A d d e n d u m

Iowa Department of Transportation
Office of Contracts

Date of Letting: April 17, 2012
Date of Addendum: April 12, 2012

B.O.	Proposal ID	Proposal Work Type	County	Project Number	Addendum
00A	78-0293-080-M	BRIDGE NEW - STEEL GIRDER	POTTAWATTAMIE	IM-NHS-029-3(80)52--03-78 IM-NHS-029-3(81)52--03-78 IM-NHS-029-3(86)52--03-78 IM-NHS-029-3(87)52--03-78 IM-NHS-029-3(94)52--03-78 IM-NHS-029-3(95)52--03-78	17APR00A.A02

PILE UPLIFT ANCHOR DETAIL AT PIERS

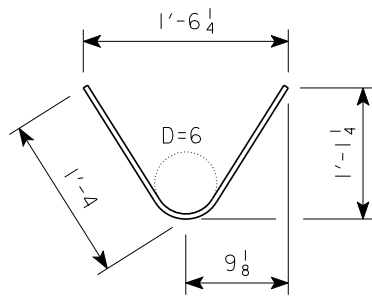
Replace Detail C and Section E-E with Pile Uplift Anchor Detail at Piers.
Replace 24 - 9f6 bars with 36 – 8f7 bars and quantity changes from 490 lb. – 481
lb.Reinforcing Steel – Totals change from 38,724 to 38,715

Replace Detail C and Section E-E with Pile Uplift Anchor Detail at Piers Replace
24 - 9f6 bars with 36 – 8f7 bars and quantity changes from 530 lb. – 481 lb.
Reinforcing Steel – Totals change from 45,883 to 45,834

Replace Detail C and Section E-E with Pile Uplift Anchor Detail at Piers.
Replace 48 - 9f6 bars with 72 – 8f7 bars and quantity changes from 1387 lb. – 961
lb. Reinforcing Steel – Totals change from 98,622 to 98,196

Replace Detail C and Section E-E with Pile Uplift Anchor Detail at Piers.
Replace 24 - 9f6 bars with 36 – 8f7 bars and quantity changes from 530 lb. – 481
lb. Reinforcing Steel – Totals change from 27,029 to 26,980

Replace Detail C and Section E-E with Pile Uplift Anchor Detail at Piers.
Replace 24 - 9f6 bars with 36 – 8f7 bars and quantity changes from 571 lb. – 481
lb. Reinforcing Steel – Totals change from 28,911 to 28,821

Replace Detail C and Section E-E with Pile Uplift Anchor Detail at Piers.
Replace 32 - 9f6 bars with 48 – 8f7 bars and quantity changes from 707 lb. – 641 lb. Reinforcing Steel – Totals change from 14,342 to 14,276

Replace Detail C and Section E-E with Pile Uplift Anchor Detail at Piers.
Replace 24 - 9f6 bars with 36 – 8f7 bars and quantity changes from 530 lb. – 481 lb. Reinforcing Steel – Totals change from 44,555 to 44,506

Replace Detail C and Section E-E with Pile Uplift Anchor Detail at Piers.
Replace 24 - 9f6 bars with 36 – 8f7 bars and quantity changes from 530 lb. – 481 lb. Reinforcing Steel – Totals change from 76,580 to 76,531

Replace Detail C and Section E-E with Pile Uplift Anchor Detail at Piers.
Replace 56 - 9f6 bars with 84 – 8f7 bars and quantity changes from 1618 lb. – 1121 lb. Reinforcing Steel – Totals change from 49,637 to 49,140

Replace Detail C and Section E-E with Pile Uplift Anchor Detail at Piers.
Replace 24 - 9f6 bars with 36 – 8f7 bars and quantity changes from 530 lb. – 481 lb. Reinforcing Steel – Totals change from 48,195 to 48,146

Replace Detail C and Section E-E with Pile Uplift Anchor Detail at Piers.
Replace 24 - 9f6 bars with 36 – 8f7 bars and quantity changes from 490 lb. – 481 lb. Reinforcing Steel – Totals change from 37,603 to 37,594

PILE UPLIFT ANCHOR DETAIL AT ABUTMENTS

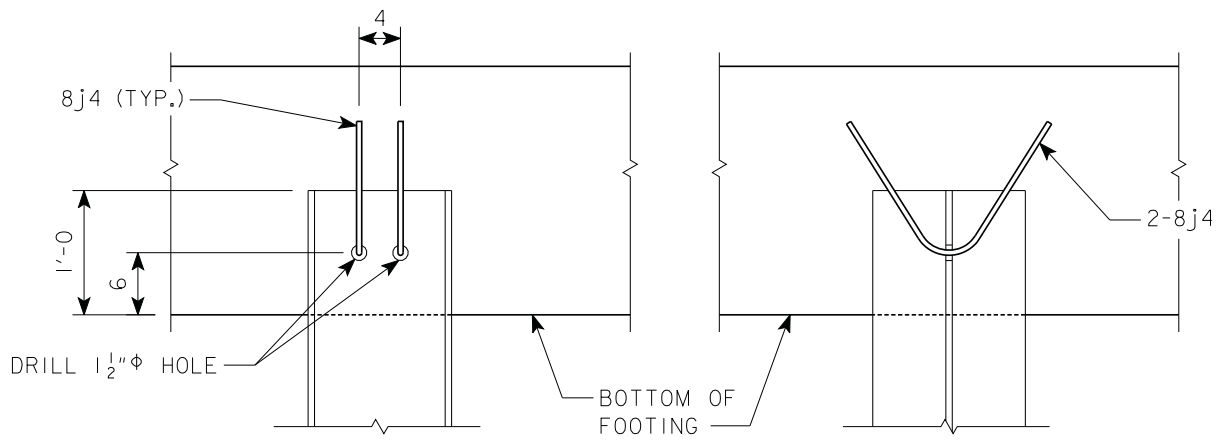
Replace Detail I and Section G-G with Pile Uplift Anchor Detail at Abutments

Replace Detail I and Section G-G with Pile Uplift Anchor Detail at Abutments

Replace 4 – 8j3 bars with 4 – 8j4 bars and quantity changes from 24lb. to 29lb. Reinforcing Steel, Epoxy Coated – Total at each Abutment changes from 9421 lb. to 9426 lb. *Reinforcing Steel, Epoxy Coated Total at each Abutment changes from 9479 lb. to 9484 lb. * Reinforcing Steel, Epoxy Coated Total for both Abutments changes from 18,958 lb. to 18,968 lb.

SHEET NUMBER: B.13

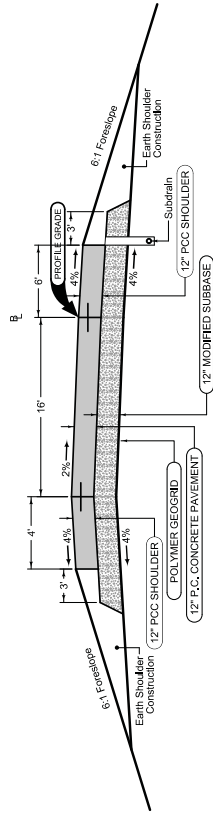
Plan Sheet B.13:

Replace plan sheet B.13 with attached plan sheet B.13

TABULATION OF PAVEMENT

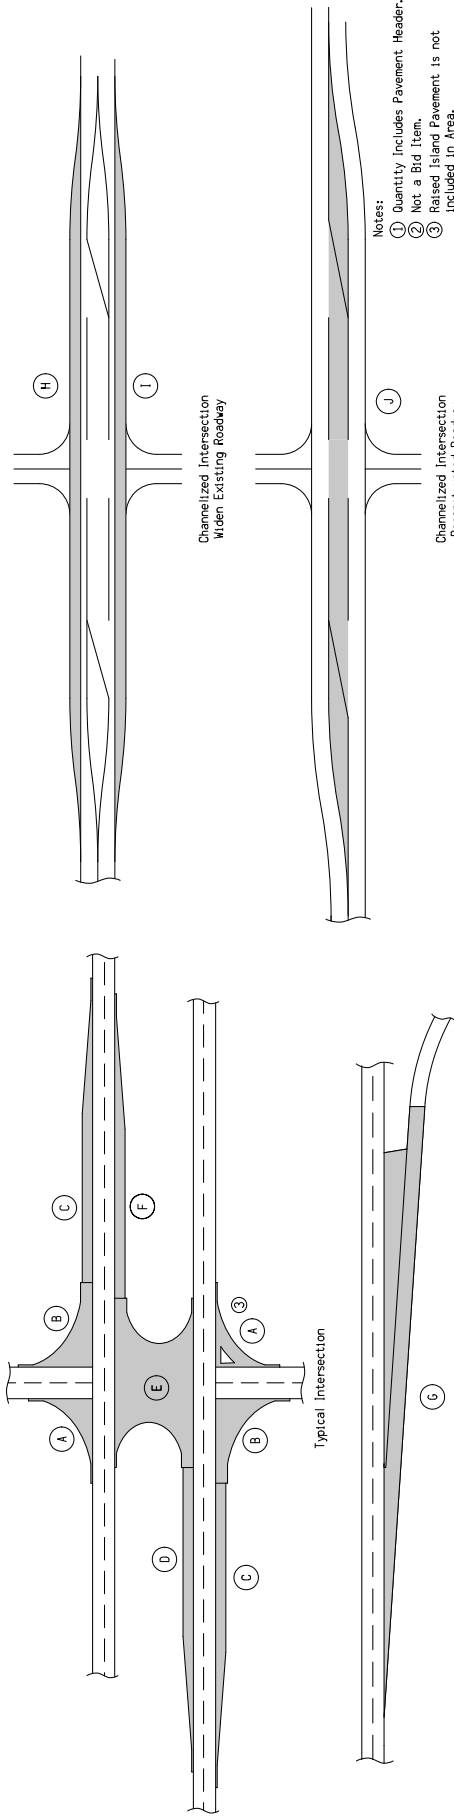
Plan Sheet C.12:

Replace plan sheet C.12 with attached plan sheet C.12

SIGN INSTALLATION DETAILS

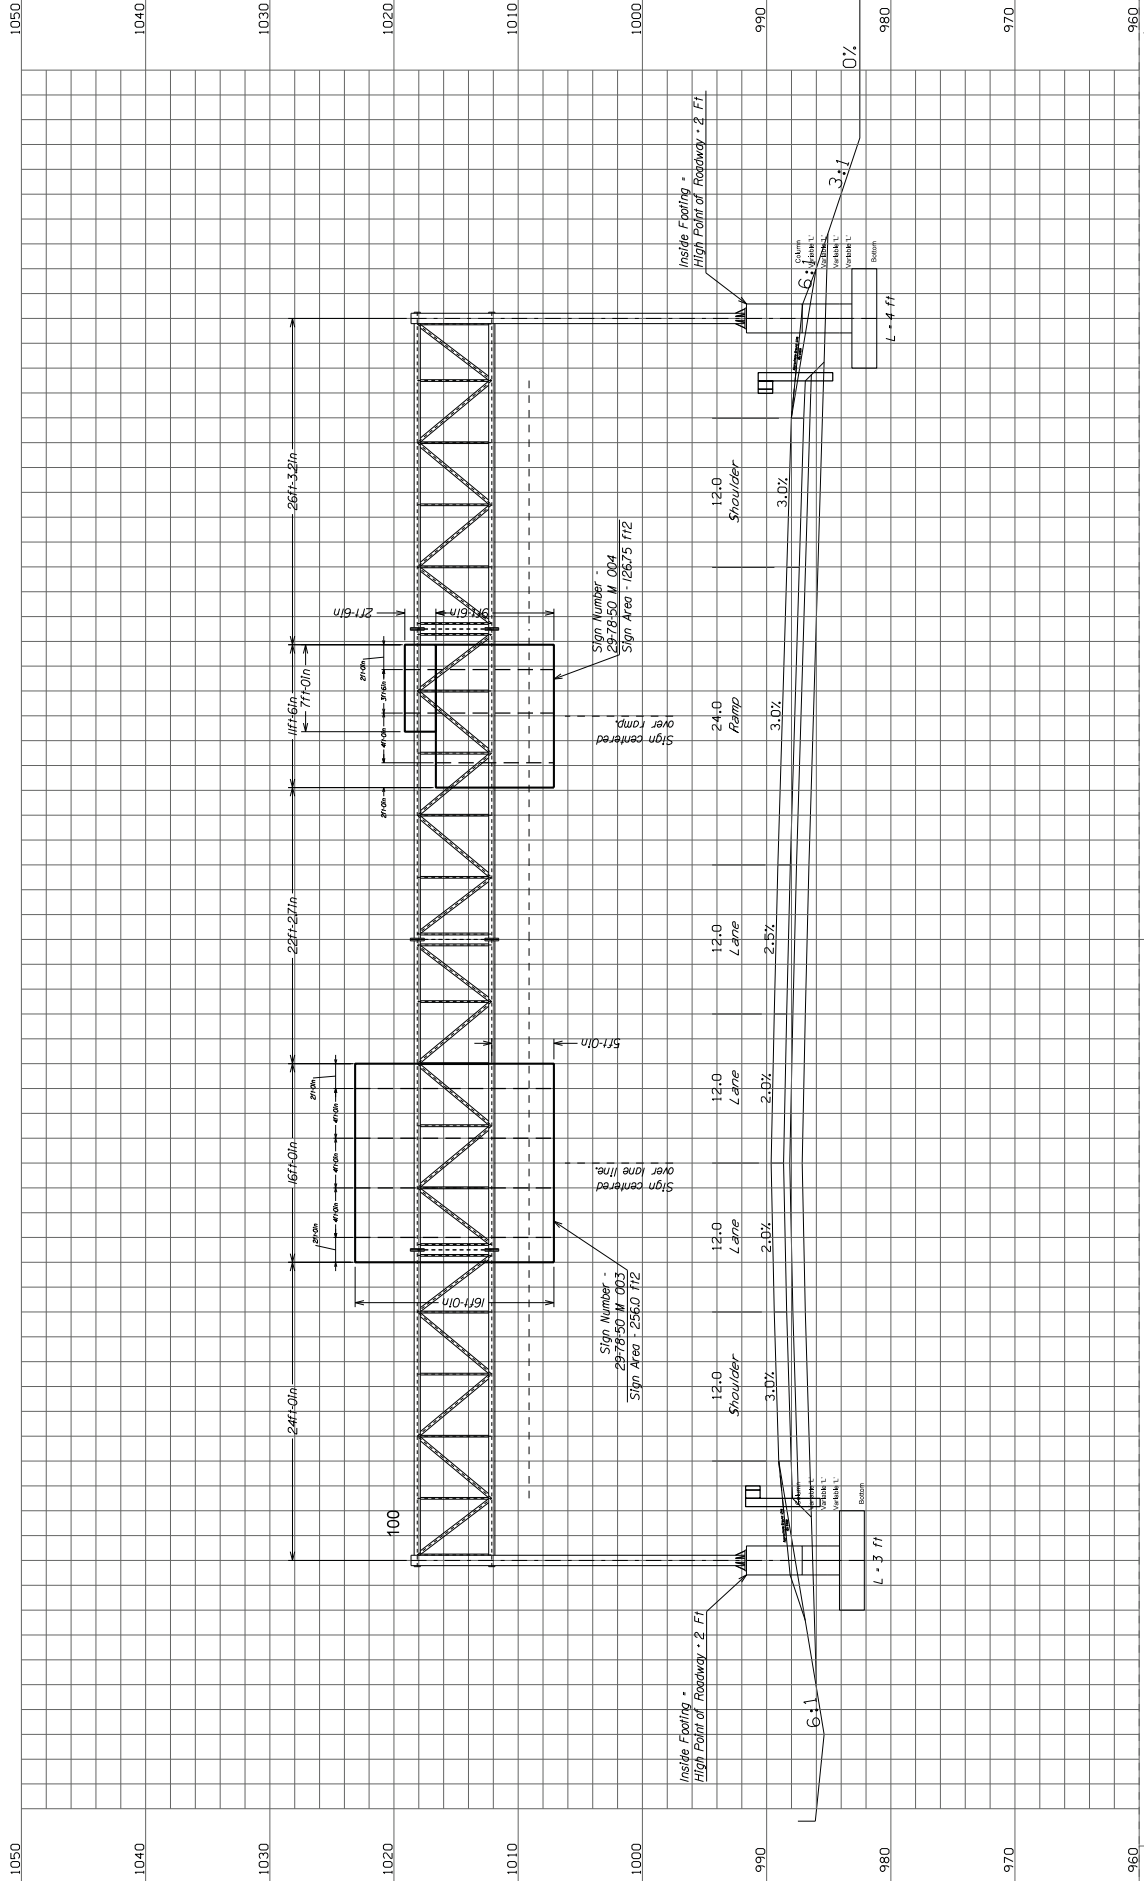
Plan Sheet N.7:
Replace plan sheet N.7 with attached plan sheet N.7
